Access Compliance Report

Public Rights-of-Way

Intersection ID: 11202	Main Street: N_TRYON_ST	Cross Street: W_15TH_ST	Location: N
ADA ID: 32E4420EB3DC	Ramp Type: Perp	Initial Pass/Fail: Fail	Overall Compliance: No
Severity Score: 22.5			
Codes/Mitigation Info/Possible Solution		Field Measurements/Component Compliance

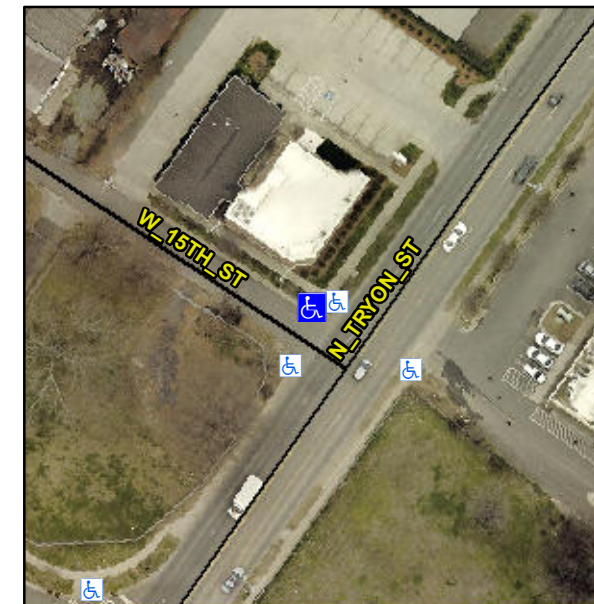
R304.5.1, R304.2.2, R304.5.3

Compliance	Description	Data	Compliance	Description	Data
N/A	Ramp Length (in)	59.0	No	Ramp Slope (%)	11.8
No	Ramp Width (in)	46.0	No	Ramp XSlope (%)	3.1
N/A	Flare Type LT	N/A	N/A	Flare Type RT	N/A
N/A	Flare Slope LT (%)	N/A	N/A	Flare Slope RT (%)	N/A
N/A	Flare Traversable LT?	N/A	N/A	Flare Traversable RT?	N/A
N/A	Landing Length (in)	N/A	N/A	DWS Provided?	N/A
N/A	Landing Width (in)	N/A	N/A	DWS Contrast?	N/A
N/A	Landing Slope (%)	N/A	N/A	DWS Length (in)	N/A
N/A	Landing X Slope (%)	N/A	N/A	DWS Full Width?	N/A
N/A	Landing Curb? (Y/N)	N/A	N/A	DWS Offset (in)	N/A
N/A	Shared Landing?	N/A			
N/A	Gutter Ponding?	N/A	N/A	Gutter Slope (%)	N/A
N/A	Gutter Lip Ht (in)	N/A	N/A	Gutter X Slope (%)	N/A
N/A	Painted X Walk1?	No	N/A	Painted X Walk2?	N/A
	X Walk 1 Direction	To SW		X Walk 2 Direction	N/A
N/A	X Walk 1 Width (in)	N/A	N/A	X Walk 2 Width (in)	N/A
	X Walk 1 Slope (%)	1.1		X Walk 2 Slope (%)	N/A
	X Walk 1 X Slope (%)	1.6		X Walk 2 X Slope (%)	N/A

Remove & Replace Entire Ramp.
